SIB 52 01 23

RECALL 23V-039: SIDE AIR BAG COVER (REAR SEATS)

This Service Information Bulletin (Revision 1) replaces SI B52 01 23 **dated January 2023**.

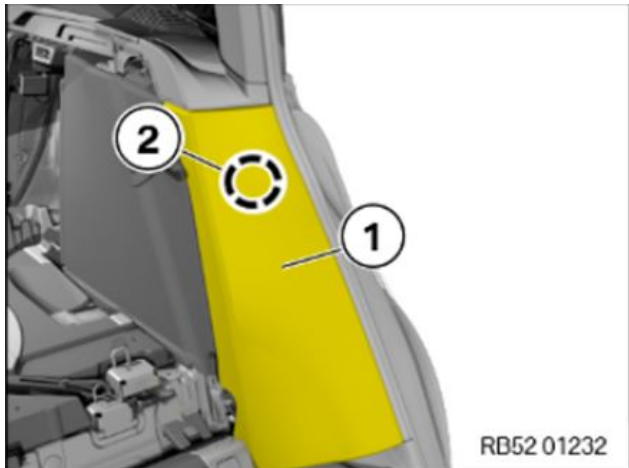
The side air bag cover panel on the rear seats may not have been produced to specifications by the supplier. In certain crashes where side air bag deployment is warranted, the cover panel may crack. If this happens, then the side air bag may not deploy as intended, which could increase the risk of injury.

Supplier backrest side panel material does not meet design criteria.

Replace both rear seat backrest side panels.

Replace backrest side panels (left and right) in accordance with repair instructions 52 26 008 (backrest side panel at the rear seat back).

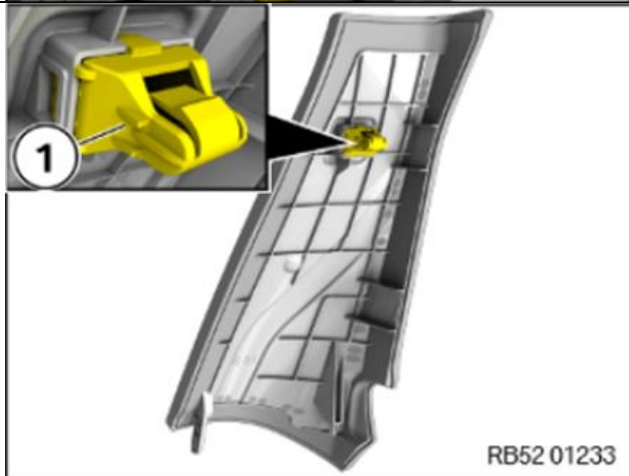
- Unclip and remove the backrest section (1) on the rear seat backrest from the clamp (2).

Check the clamp (1) for damage. A replacement clamp should be present on the new part.

Repeat for opposite side of vehicle.
